Date: Oct 28, 1998

To: T10 Committee (SCSI)

From: George Penokie (IBM)

Subject: Persistent Reservations

Figure 1 - Device server interpretation of PREEMPT service action

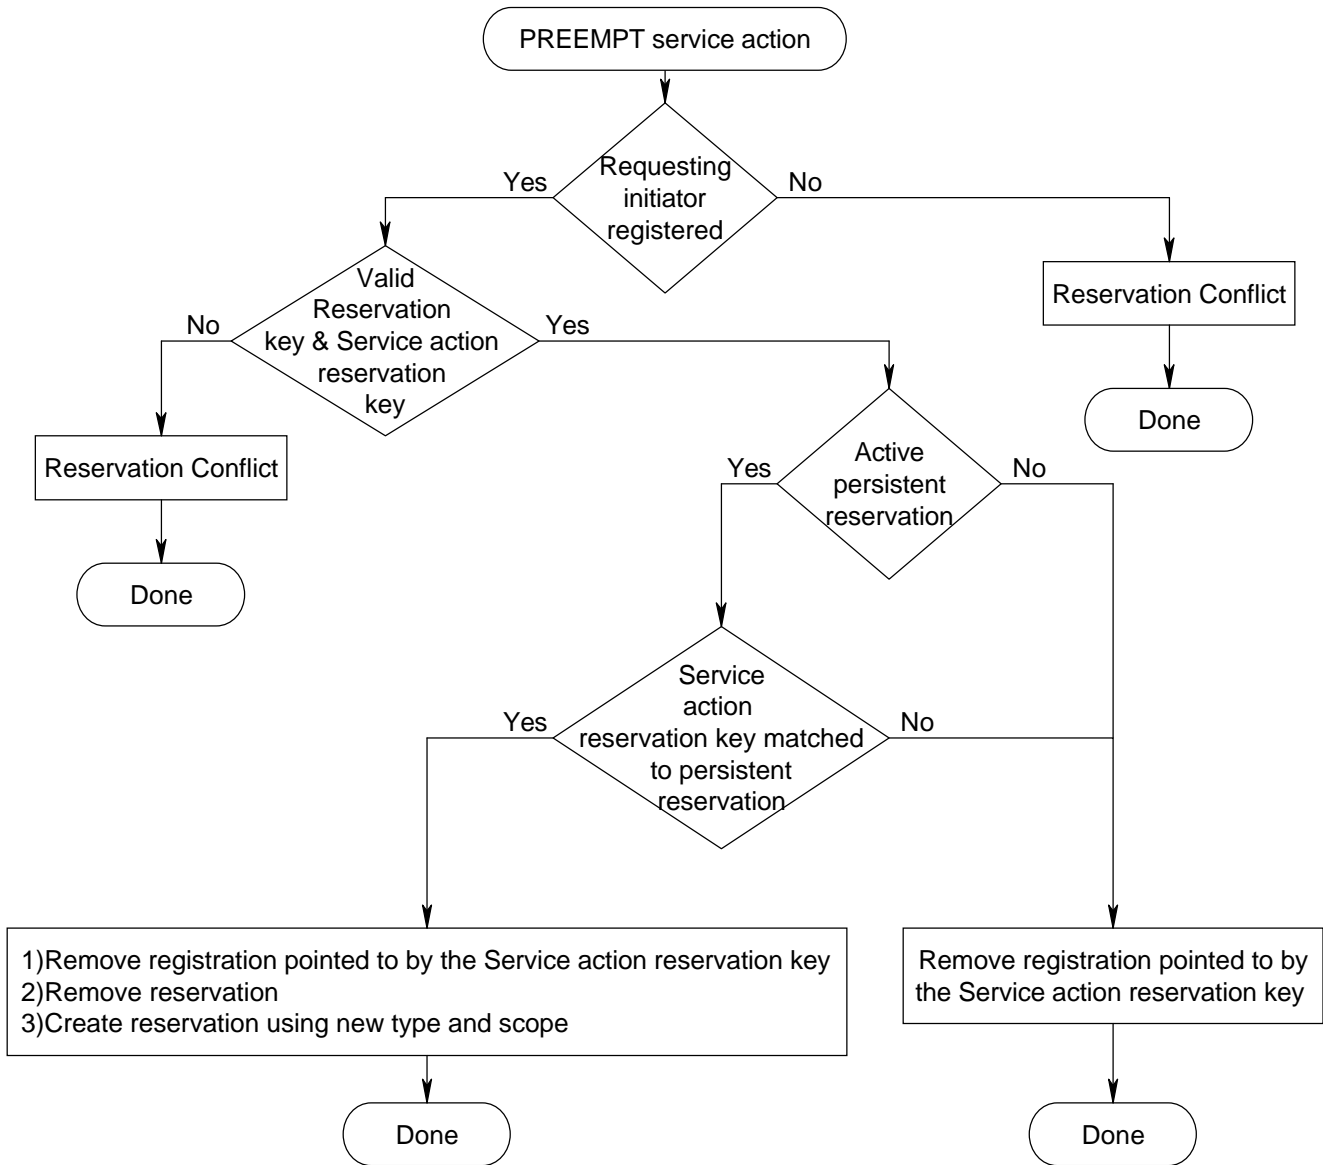
See figure 1 for a description of how a device server should interpret a PREEMPT service action to determine the actions it should take (i.e., preempt persistent reservation, preempt registration or preempt both registration and persistent reservation).
